Metropolitan Development Commission Plat Committee (January 10, 2024) Meeting Agenda

PLAT COMMITTEE **January 10, 2024**

SIDEWALKS

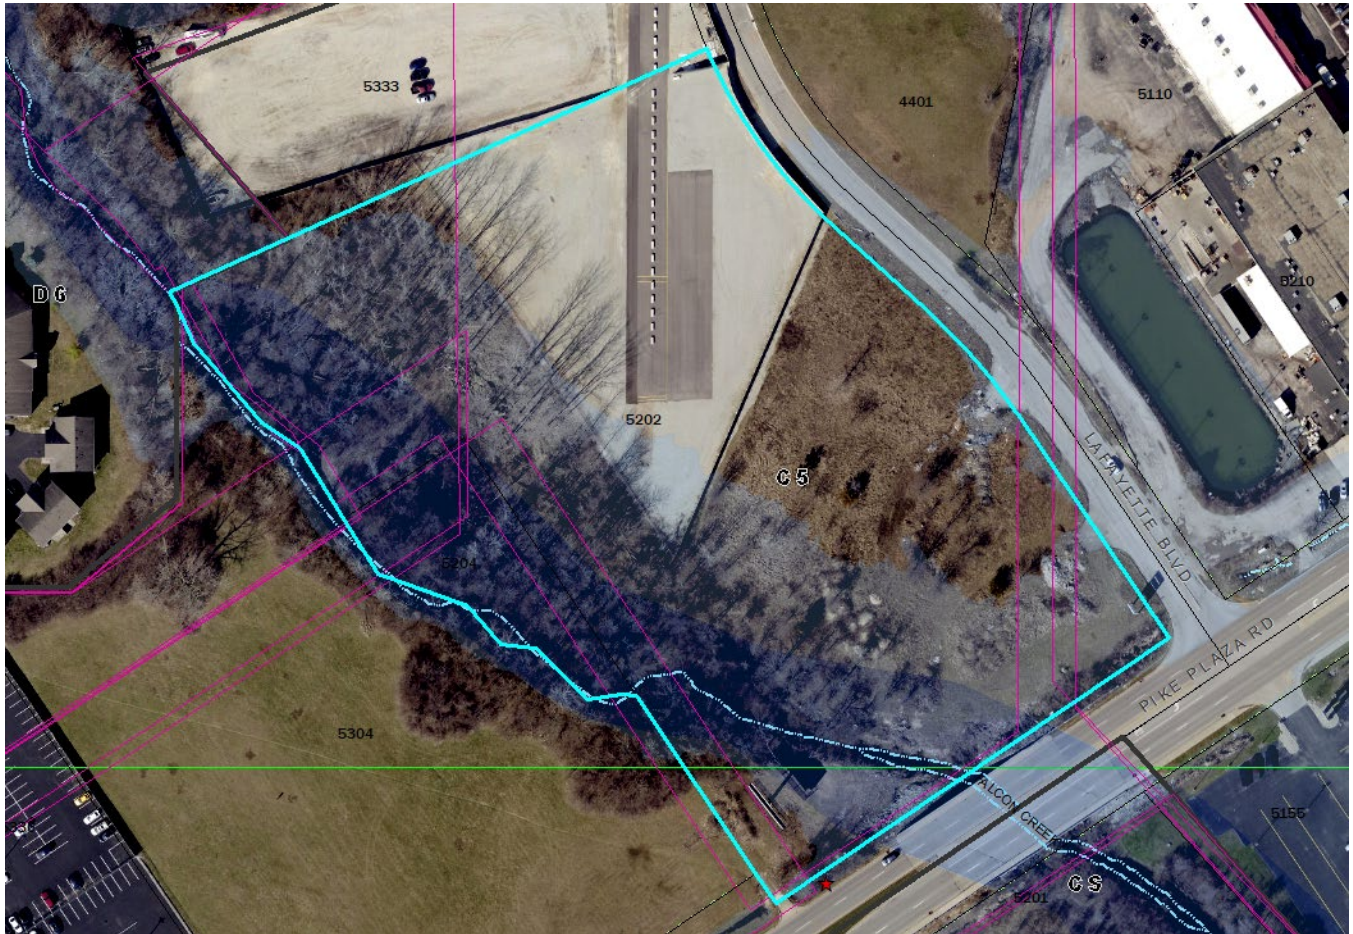
Sidewalks would be required to be installed along Pike Plaza Road and Lafayette Boulevard per the ordinance. There is a drainage ditch along Pike Plaza Road; however, there is a bridge including a sidewalk over Falcon Creek on the south frontage, which would suggest that installation of sidewalks is possible. There is also evidence of people walking on this frontage per the Google Street View image below, indicating that pedestrian infrastructure is needed. There are no topographic challenges for installing sidewalks along Lafayette Boulevard. Therefore, staff is recommending denial of the waiver.

If the plat committee approves the waiver against staff's recommendation, a contribution in lieu of sidewalk installation should be required as a condition of approval subject to Section 744-301.G.

EXHIBITS

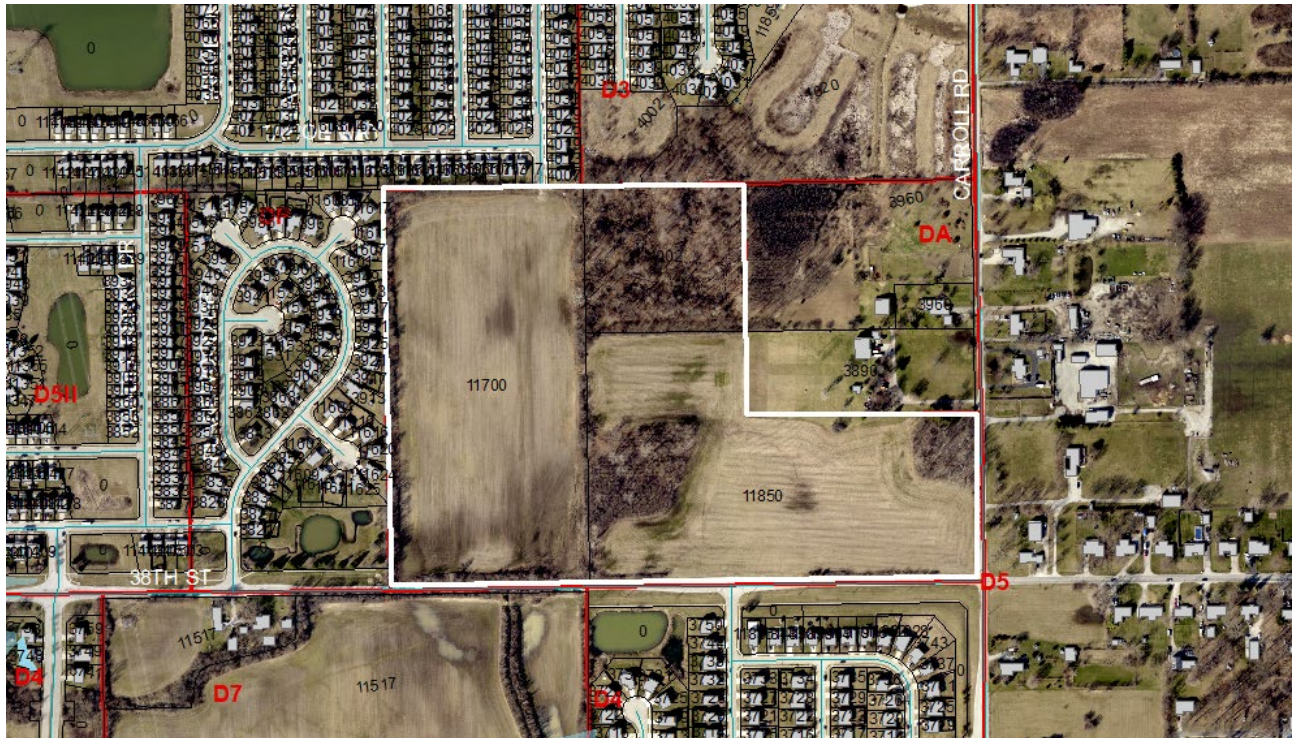
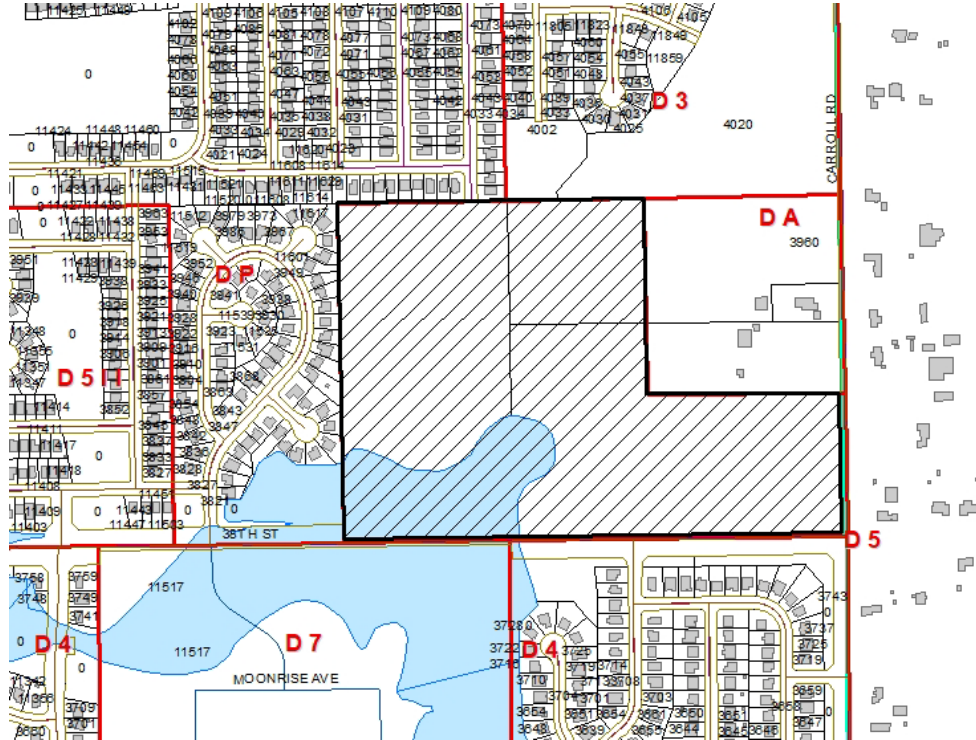
This petition was continued from October 11, 2023 to November 8, 2023, from November 8, 2023 to December 13, 2023, and from December 13, 2023 to January 10, 2024, at the request of staff, to allow time for the petitioner to correct issues with the plat.

As of this writing, a revised plat has not been submitted. However, staff is expecting revisions prior to the hearing. Staff may provide an updated staff report at the hearing.

12. That a dedicatory statement be included in the Owner's Certificate on the plat, prior to final plat recording.
13. That a statement be added to the plat that the "eyebrow" portion of the right-of-way be maintained by the Home Owner's Association. The eyebrow area shall be "hatched" or otherwise indicated on the plat and included in the key, prior to final plat recording.

17. That a revised Natural Infrastructure Plan be submitted for Administrator's Approval prior to final plat recording.
18. That a revised Traffic Control Plan be submitted for Administrator's Approval prior to final plat recording.

19. That a revised Tree Inventory/Preservation Plan be submitted for Administrator's Approval prior to any earth movement or tree removal.
20. That the dedication of right-of-way along both perimeter streets be revised to match the requirements of the zoning commitments.

21. That a lighting plan compliant with Section 744-600 of the Consolidated Zoning and Subdivision Ordinance be submitted prior to recording the final plat.
